REPORT TO THE
NUCLEAR REGULATORY COMMISSION
FROM
PACIFIC GAS AND ELECTRIC COMPANY
ON
THE SEISMIC IMPLICATIONS
OF
THE TMI-2 ACCIDENT
TO
DIABLO CANYON

September 27, 1979

2.0 QUESTIONS FROM THE AD HOC ACRS SUBCOMMITTEE ON THE TMI-2 ACCIDENT
IMPLICATIONS FOR THE OCTOBER 3, 1979 MEETING

FIGURE 8.2-2
 OFF-SITE INTERCONNECTION DIAGRAM

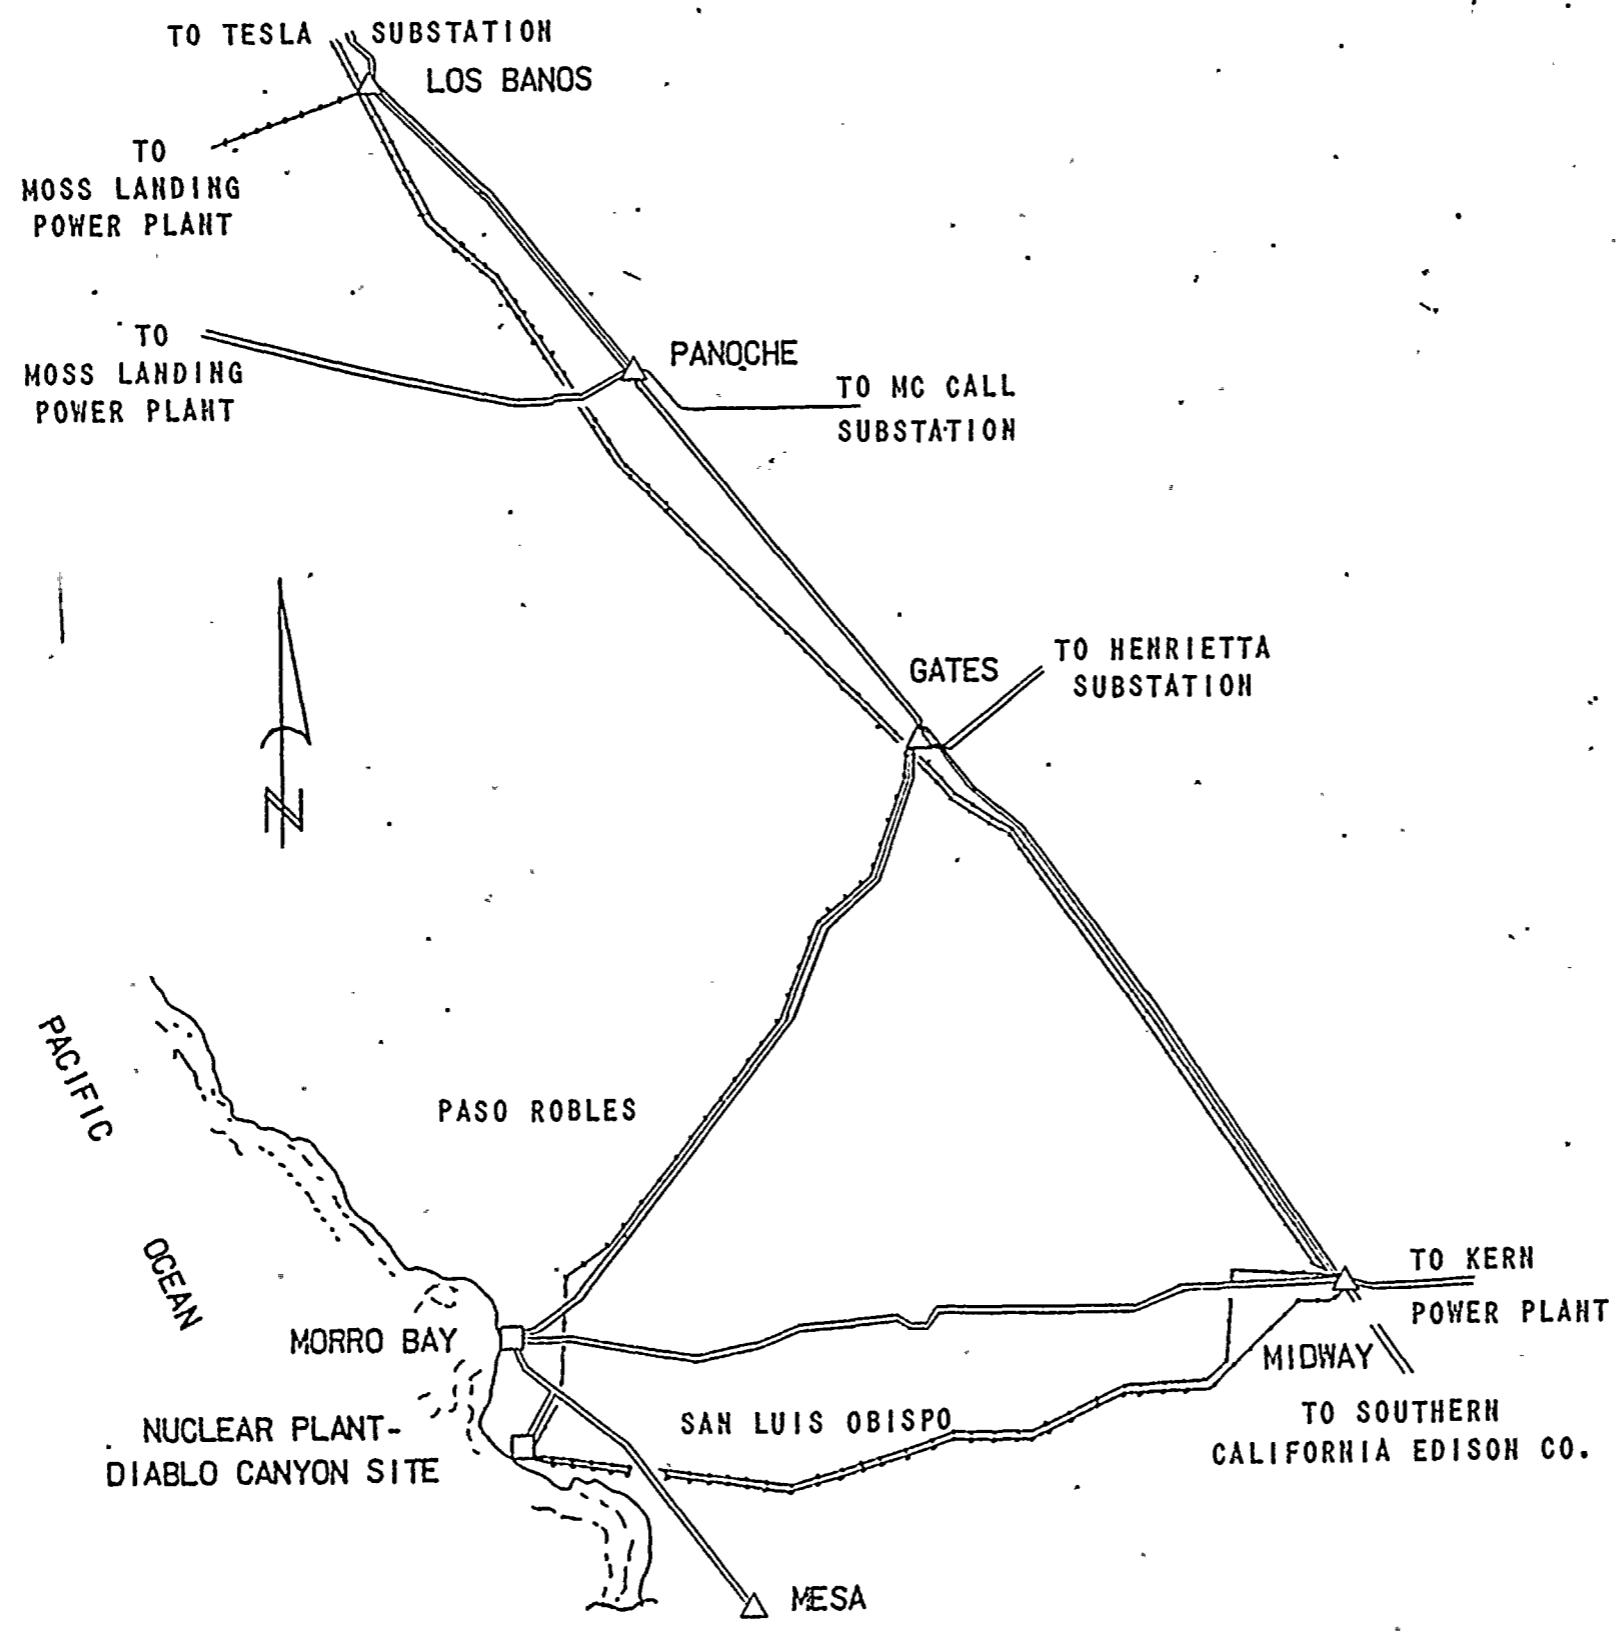
The continued availability of offsite power depends upon the seismic resistance of system transmission lines, generating plant switchyards, and system substations to seismic activity that could conceivably cause a concurrent Diablo Canyon outage.

The attached FSAR Figure 8.2-2 shows the location of the substations and power plants available to supply power to Diablo Canyon following a forced outage.

As indicated in FSAR Figure 8.2-2, there are potential sources of backup power far removed from the Diablo Canyon site. It is, therefore, unlikely that any earthquake could result in a loss of such power to the Diablo Canyon station auxiliaries. Any interruption which did take place would not be expected to last beyond the time necessary for switchyard repair. However, in the extremely unlikely event of major switchyard damage at Diablo Canyon, power restoration would depend on the deployment of mobile substations. It is expected that this could be accomplished within eighteen hours. As discussed in previous sections of this report, onsite Category I equipment is available to mitigate any postulated event during this time.
